## HISTORIC AND DESIGN REVIEW COMMISSION

**HDRC CASE NO:** 2025-135  
**ADDRESS:** 240 E LULLWOOD AVE  
**LEGAL DESCRIPTION:** NCB 6727 BLK 3 LOT 21 AND 22  
**ZONING:** RM-4, H  
**CITY COUNCIL DIST.:** 1  
**DISTRICT:** Monte Vista Historic District  
**APPLICANT:** KRISTEN WEBER/Lullwood Studio  
**OWNER:** KRISTEN WEBER/WEBER KRISTEN L & DANIEL R STACY  
**TYPE OF WORK:** New construction of a 2-story rear accessory structure  
**APPLICATION RECEIVED:** May 15, 2025  
**60-DAY REVIEW:** July 14, 2025  
**CASE MANAGER:** Bryan Morales  
**REQUEST:**

The applicant is requesting a Certificate of Appropriateness for approval to construct an approximately 1,992 sf 2-story rear accessory structure.

**SITE PLAN:** 240 E LULLWOOD  
SCALE: 1/8" = 1'-0"

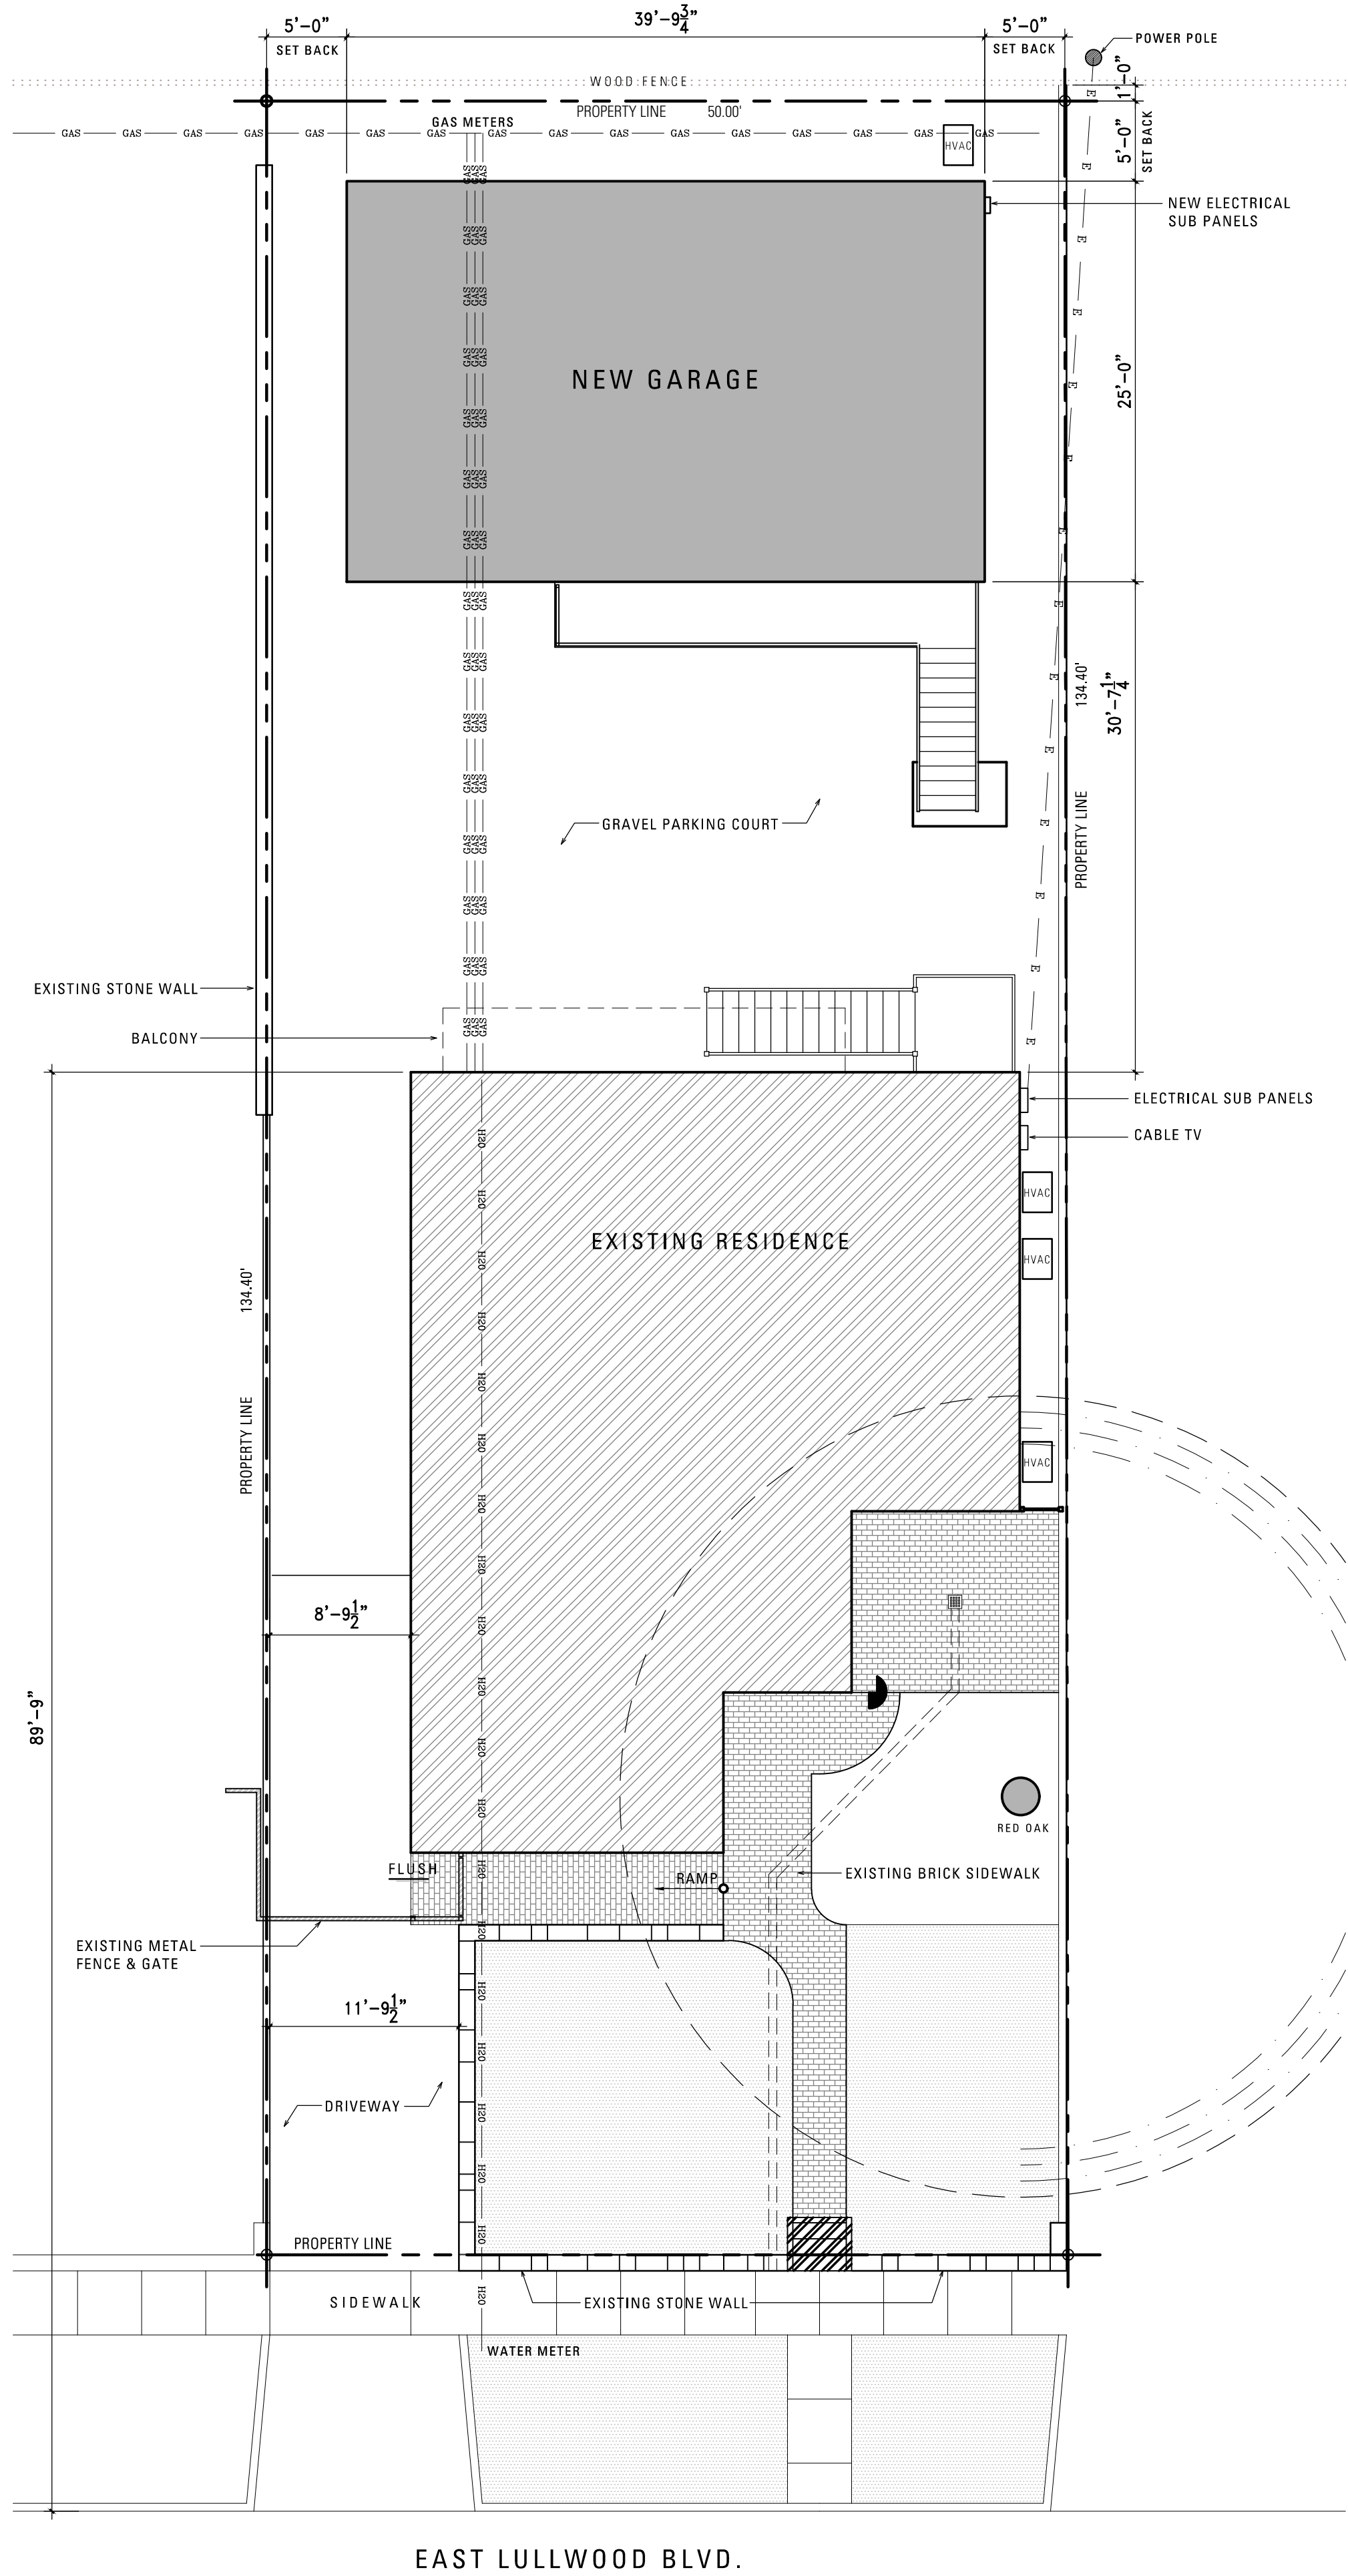
- d. LOT COVERAGE – The applicant is requesting approval to construct a 2-story detached rear accessory structure with a garage. The lot is approximately 6,700 sf. According to the Historic Design Guidelines, the building footprint for new construction should be limited to no more than 50 percent of the total lot area, unless adjacent historic buildings establish a precedent with a greater building to lot ratio. A building footprint should respond to the size of the lot. The combined square-footage of the existing primary structure, secondary structure, and the proposed rear accessory structure is approximately 2,854 sf or 43% of the total lot coverage. Staff finds that the footprint of the proposed rear accessory structure generally appropriate.

- e. ORIENTATION & SETBACKS – The applicant has proposed both an orientation and setback for the new accessory structure that are consistent with the Guidelines for New Construction 5.B.

- iv. That the applicant meets all setback standards as required by city zoning and obtain a variance from the Board of Adjustment if applicable.
